Design Review Board Study Session

SUBJECT: DR14-34, POPEYES LOUISIANA KITCHEN

DR14-34, project name: site plan, landscape plan, grading and drainage, elevations, floor plans, lighting, colors and materials for approximately 1.48 acres located at the northeast corner of Arizona Avenue and Desert Lane zoned General Commercial (GC) with a Planned Area Development (PAD) overlay.

DR14-34 : Popeyes Louisiana Kitchen
Exhibit 4 - Site Plan
October 9, 2014

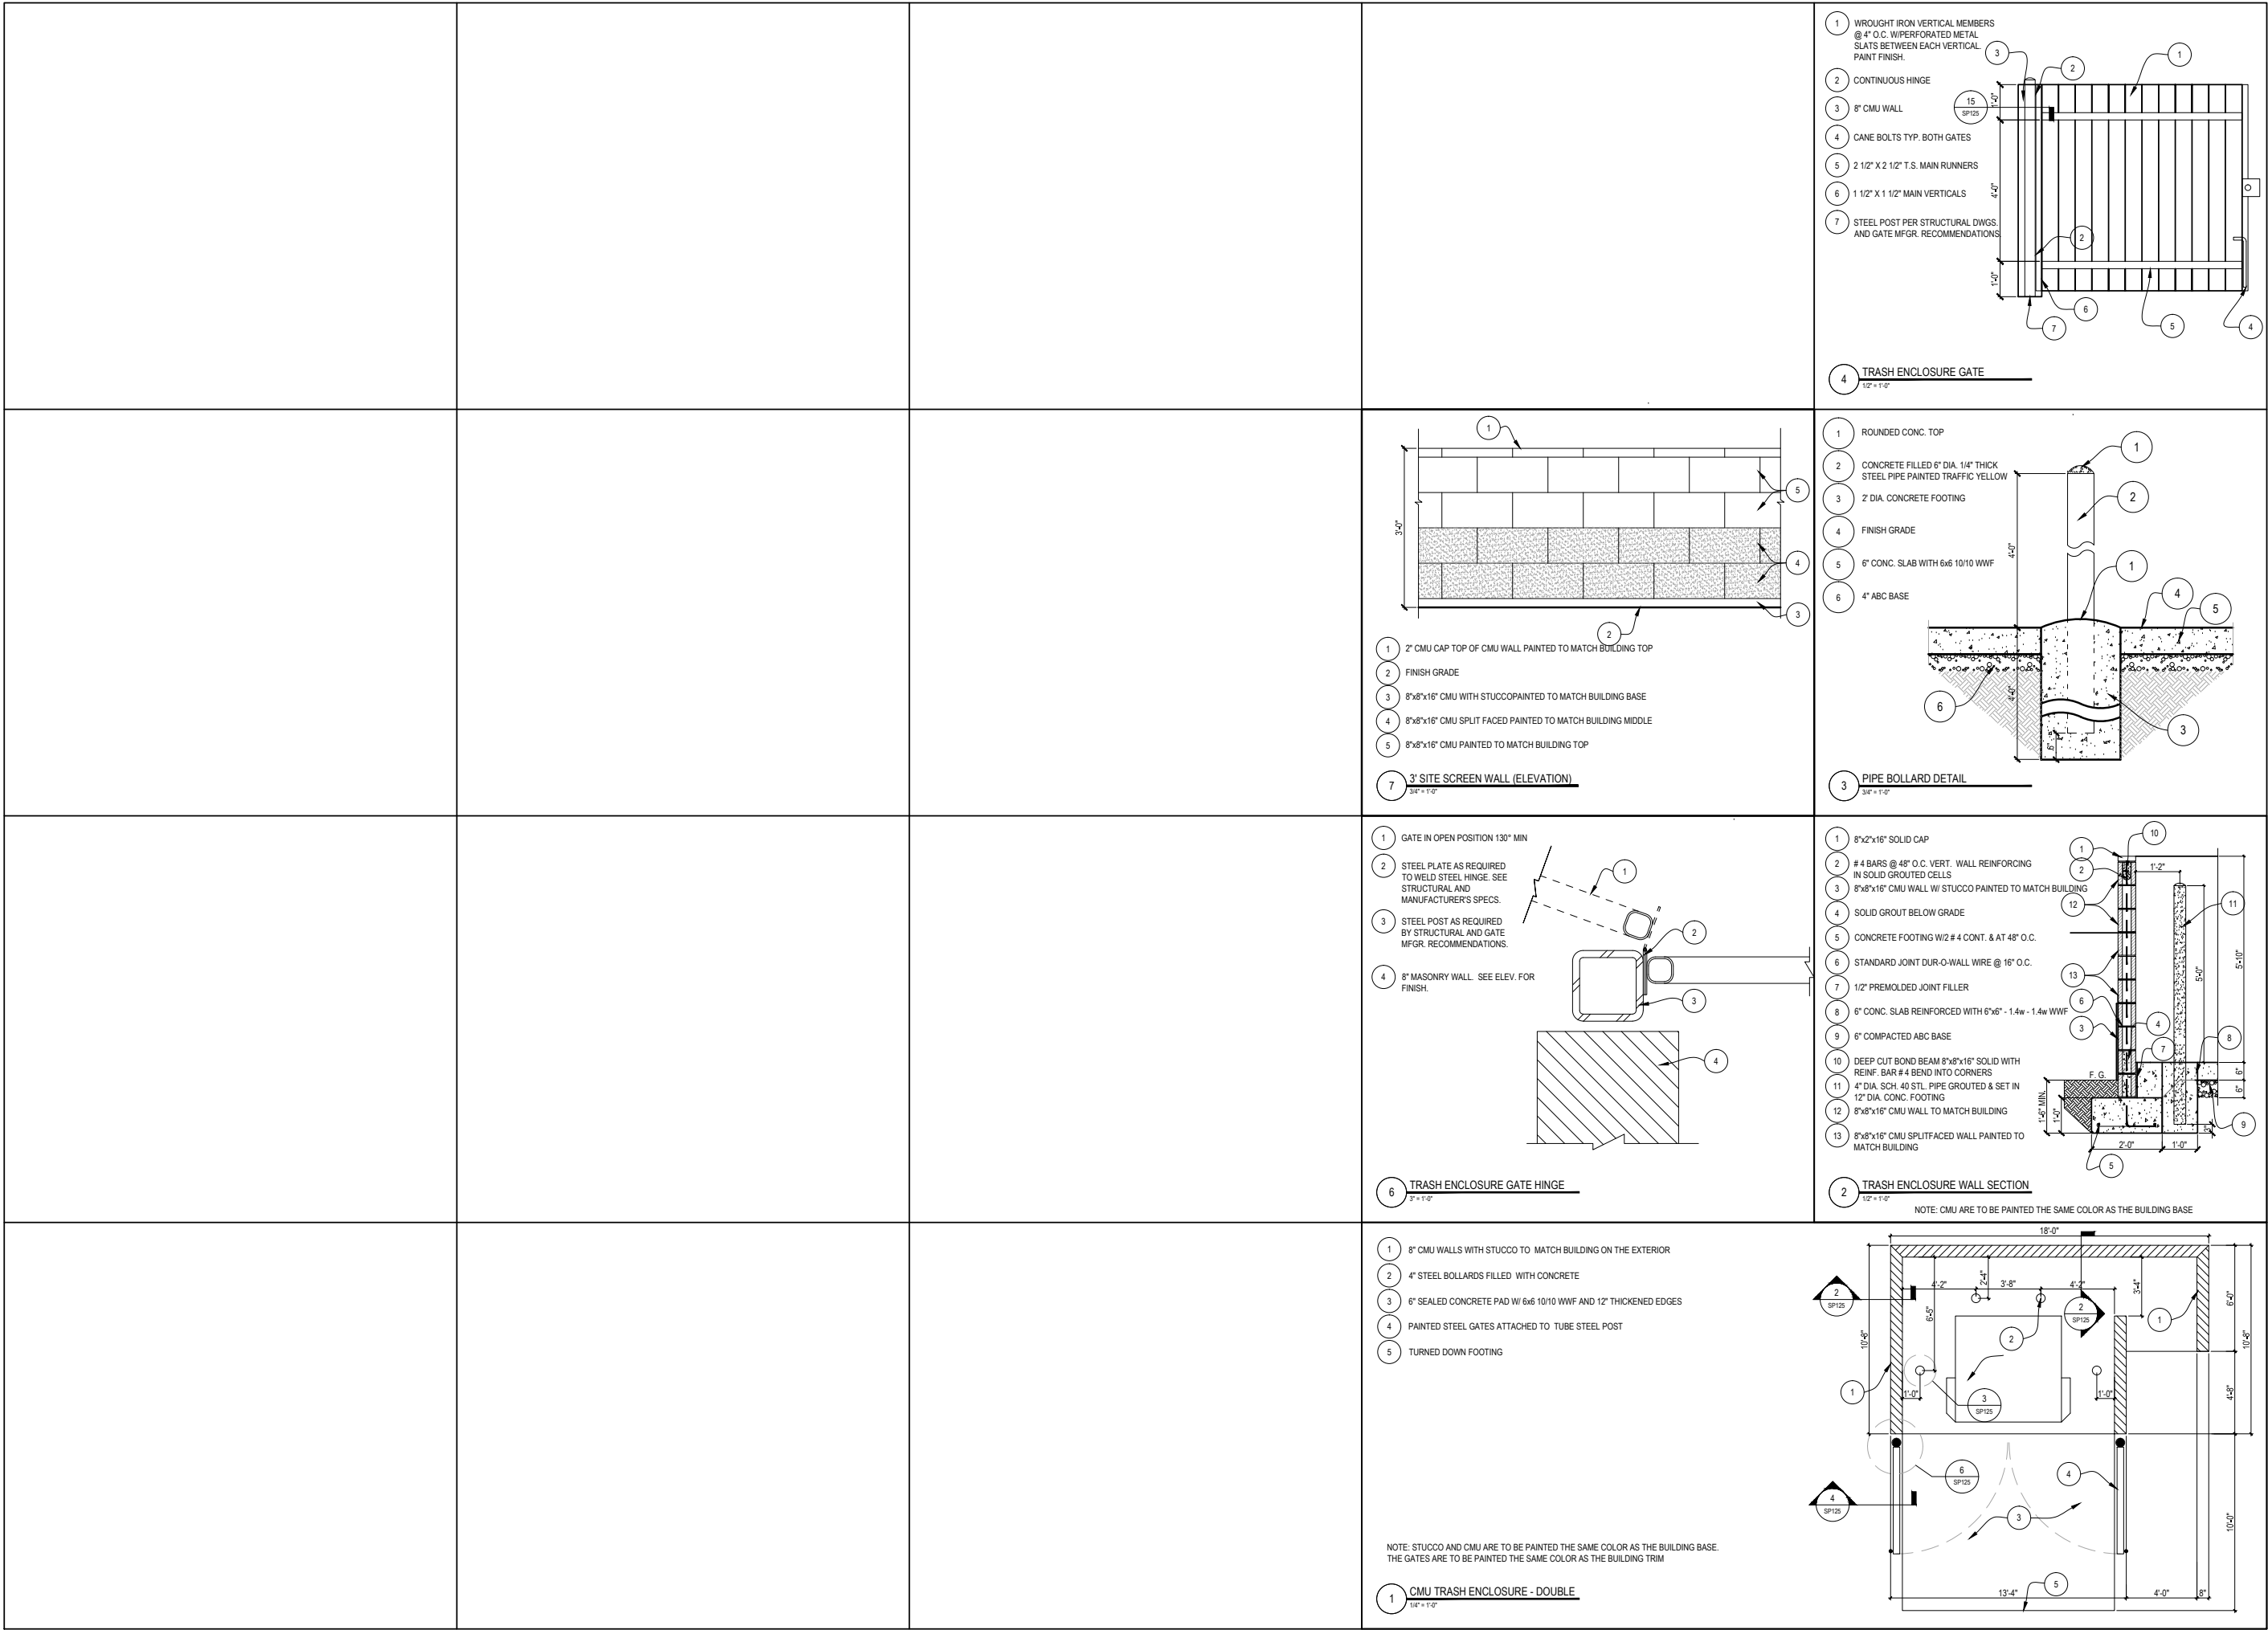
being the addition of the drive-through. The drive-through meets the stacking requirements based on the pick-up window location. Staff does have some concern that there may not be enough stacking behind the order location, but there is no Code provision for this topic. Staff supports the outdoor dining area. One parking area with 9 spaces will need to be adjusted to meet the requirement for a maximum of 8 parking spaces between landscape islands. Staff does not support a narrow 2' median between a main drive aisle and a drive through that has no screening or landscape. The median should be increased to a minimum of 5' and screening should be provided around the entire length of the drive-through.

DR14-34 : Popeyes Louisiana Kitchen
Exhibit 5 - Landscape Plan
October 9, 2014

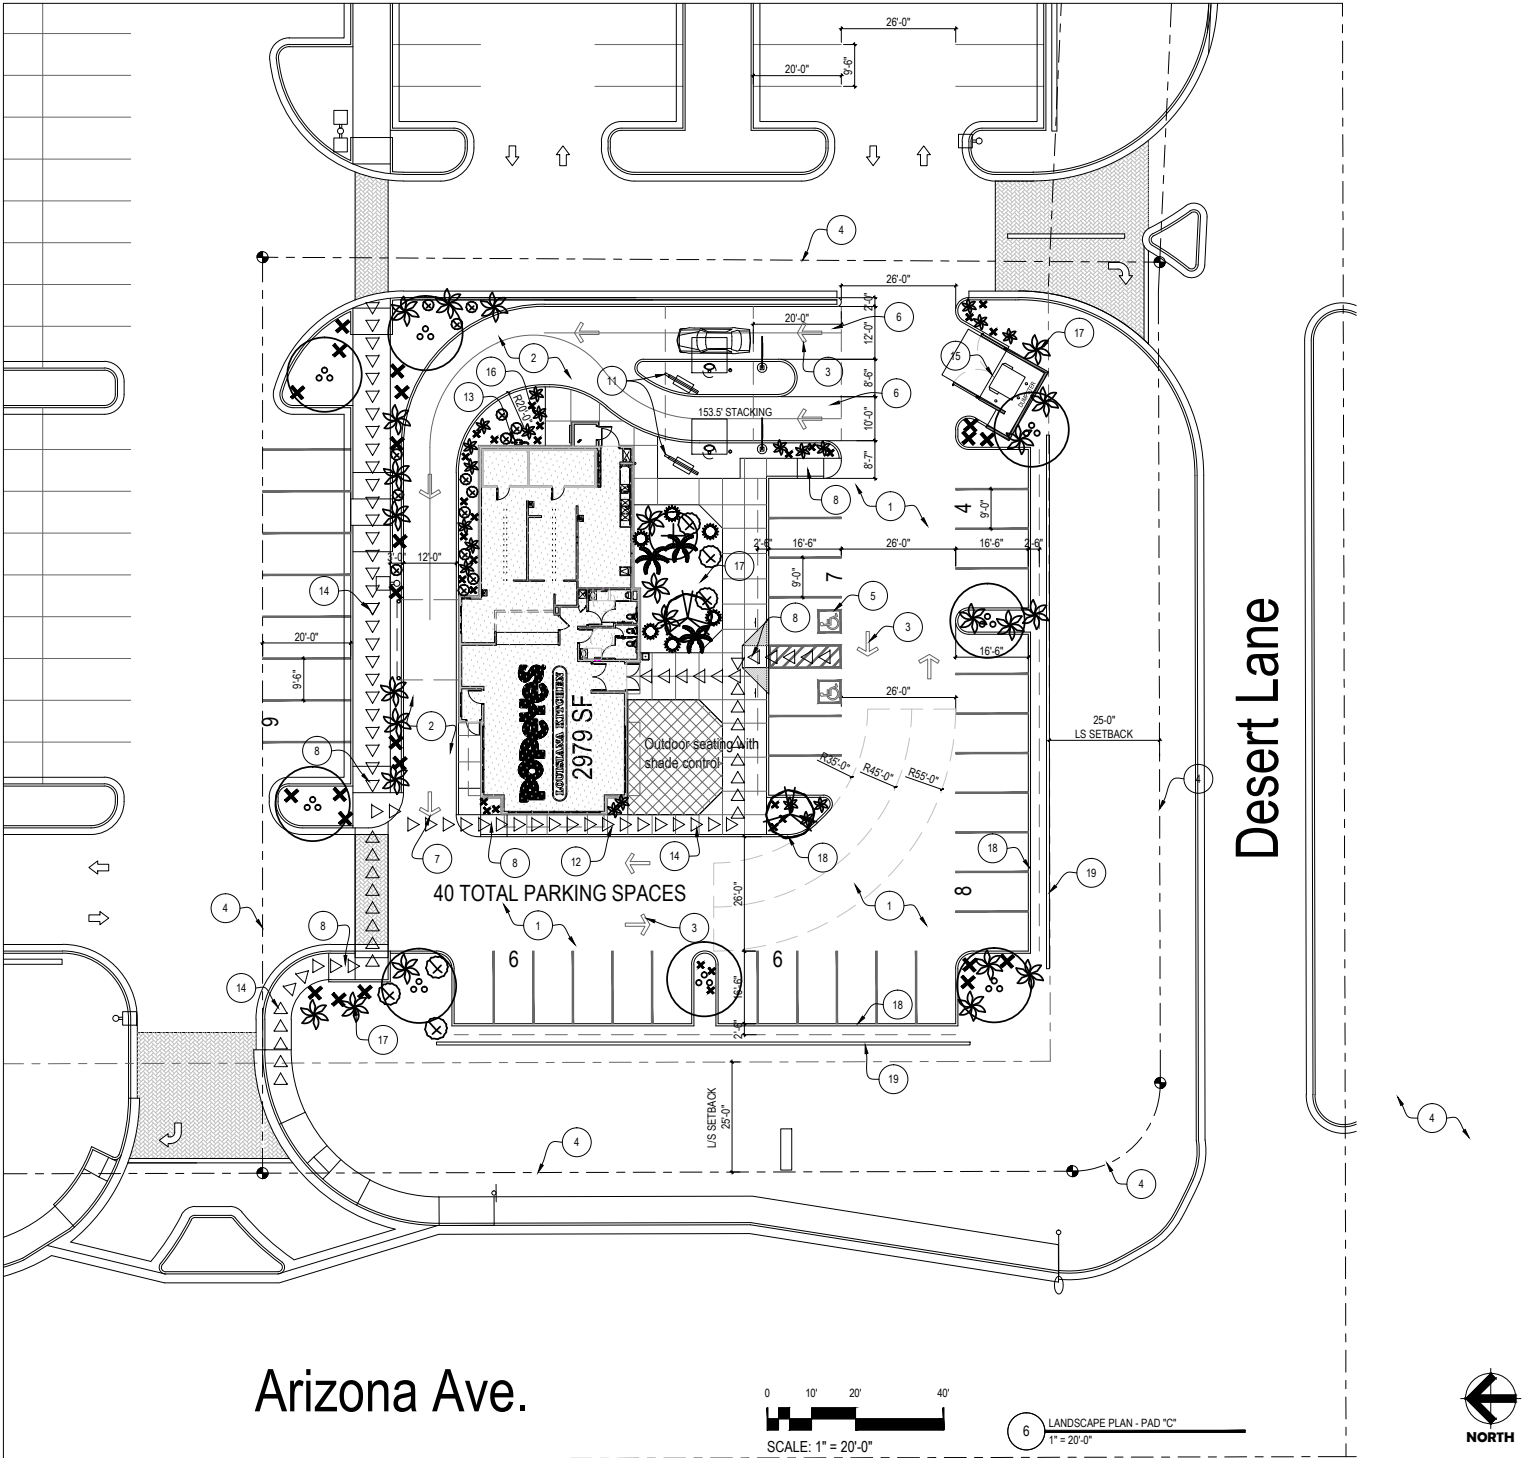
Staff recommends that the Palo Brea, Desert Carpet Acacia, Red Bird of Paradise and the Agave Geminiflora be changed out for plants on the approved shopping center palette. Staff would also prefer that agaves be located away from parking or pedestrian areas. In 1st Review, staff has requested details and information regarding screen walls, trash enclosure, the outdoor dining, shade cover and furnishings. It is anticipated that these will match those approved for Winco (Pad A).

**DR14-34 : Popeyes Louisiana Kitchen
Exhibit 6 - Grading and Drainage
October 9, 2014**

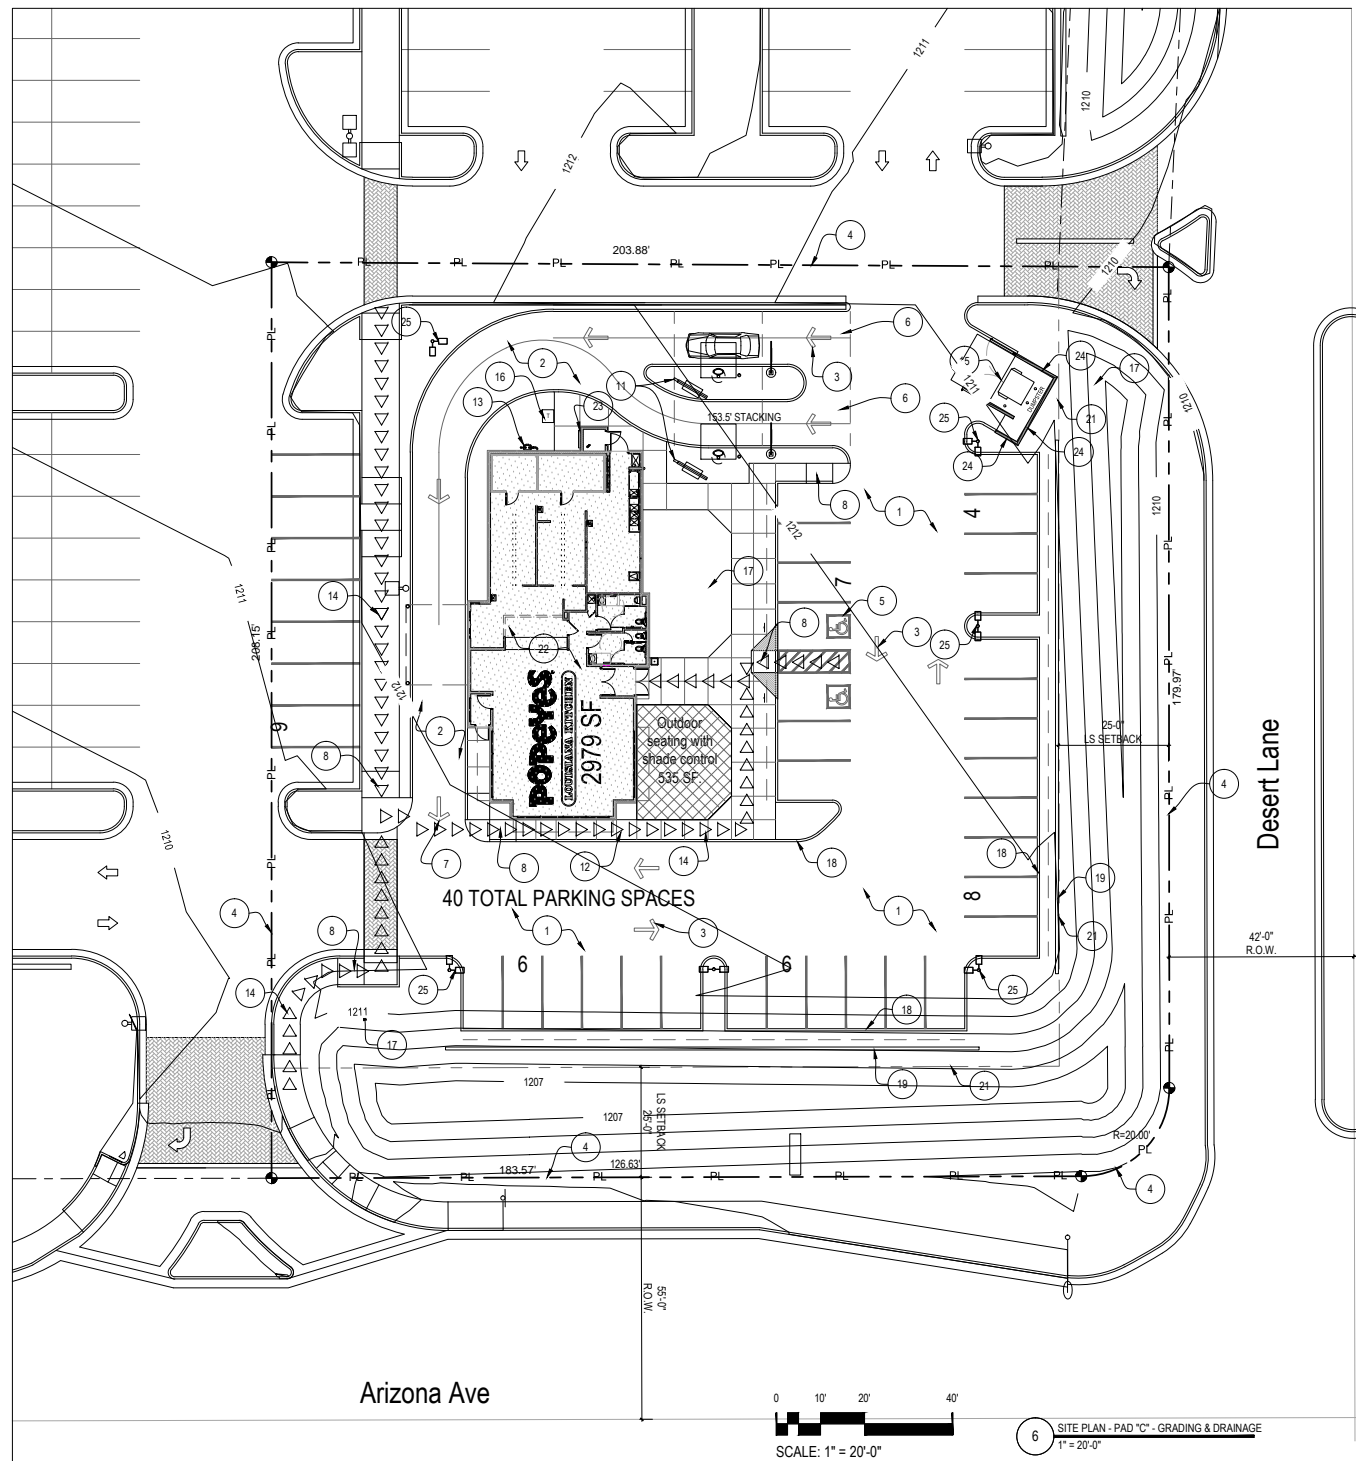
Pad C is graded to drain to the basins approved in DR12-24 Winco (Pad A). No other grading or drainage changes have been made since the original approval.

DR14-34 : Popeyes Louisiana Kitchen
Exhibit 7 - Elevations
October 9, 2014

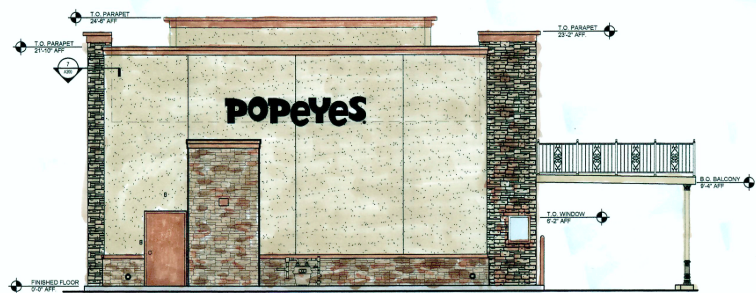
The elevations are the same design as approved last month for the Winco shopping center at Market and Pecos. The color palette has been adjusted to this site. However, staff would like the field color either be Benjamin Moore Monterey White or Wilmington Tan and the cornice accent Maryville Brown. It may be the applicant's choice if they wish to match the awning to Copper Cote instead of Tiger Drylac.
